Planning Committee

Wednesday 3 May 2023 6pm

PC2304-1 HICKORY STREET, NO. 8 (LOT 30), SOUTH FREMANTLE - TWO STOREY ADDITIONS AND ALTERATIONS INCLUDING A ROOF TOP TERRACE ADDITION TO EXISTING SINGLE HOUSE (ED DA0263/22)

ADDITIONAL OFFICERS COMMENT

Figure 1. Proposed east elevation showing change to roof form and pitch at third level

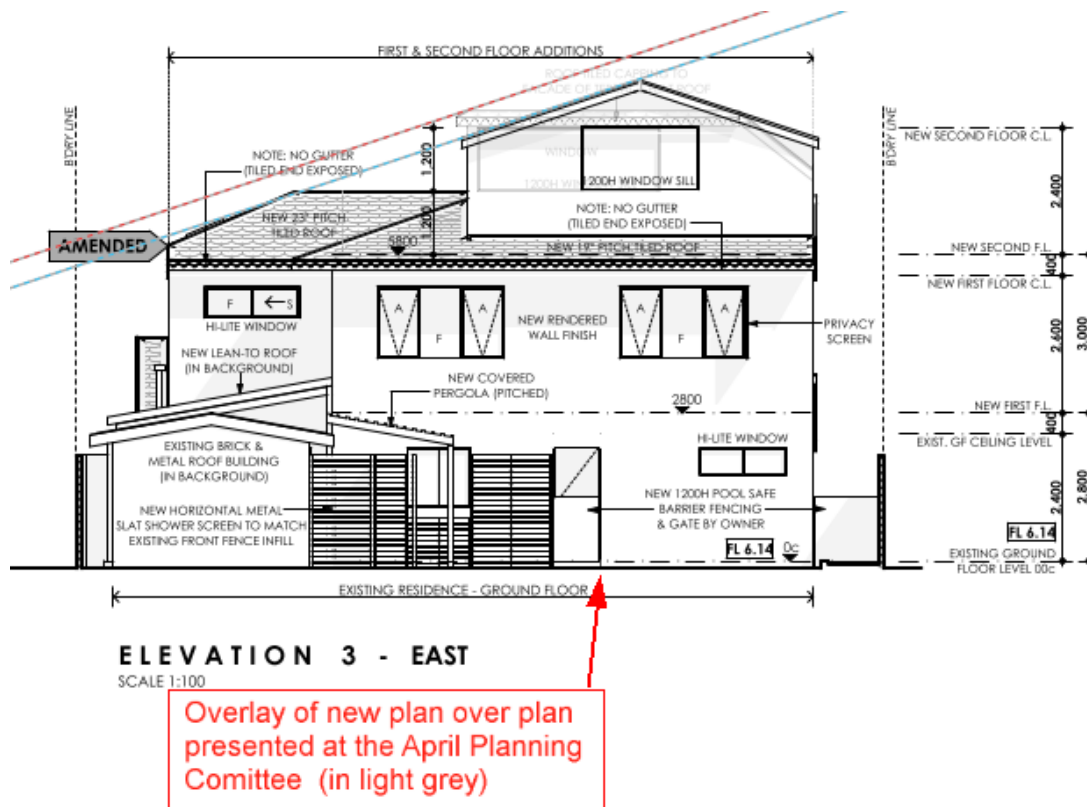
- While the amended plans add additional external wall height to the northern side and overall roof height with the gabled roof, the actual overshadowing of the southern lot has been reduced due to the shorter southern external wall height (reduced by 300mm) and the new pitched roof actually improves solar access to the southern neighbour (see further discussion in overshadowing section below). The image below illustrates how the pitched roof improves the shadow impact from this level by reducing the obstruction of sunlight with the angle of the sun:

Figure 2. Diagram illustrating shadow impact of proposed development upon adjoining southern dwelling (No. 10 Hickory – east elevation shown above). The area shaded red demonstrates the reduction in extent of overshadowing due to changed roof pitch and form.

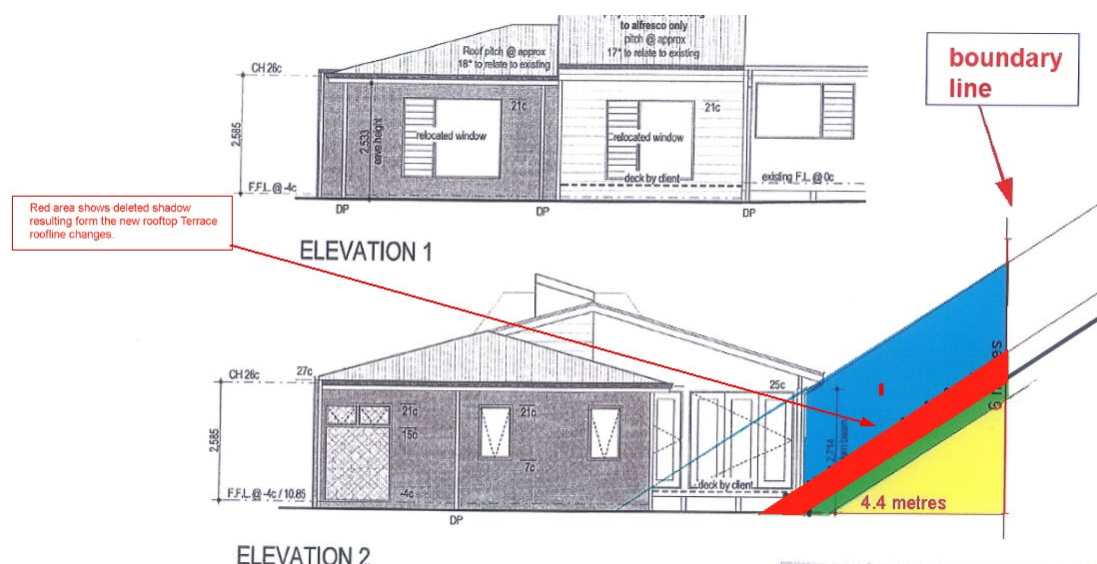
- The applicant has amended plans that have further reduced overshadowing of the adjoining southern neighbour by 6.7m². This reduction results in an overall overshadowing area of 127.3m² (or 27.97% coverage of the adjoining southern property) compared with the previous plans (dated 3 March 2023) which proposed 134m² (or 29.45%) overshadowing of the southern property.
- Importantly, the extent of overshadowing over the more sensitive outdoor living area (alfresco) and habitable room windows of the adjoining dwelling, which was previously the main concern, has been partly reduced and therefore the potential overshadowing impact upon active habitable spaces has improved under the amended plans and is considered acceptable.

See the below comparative plans that illustrate how the shadow impact has been reduced between the plans previously considered (dated 3 March 2023) vs. the amended plans (dated 14 April 2023) – the red colouring shows how the shadow impact has been reduced:
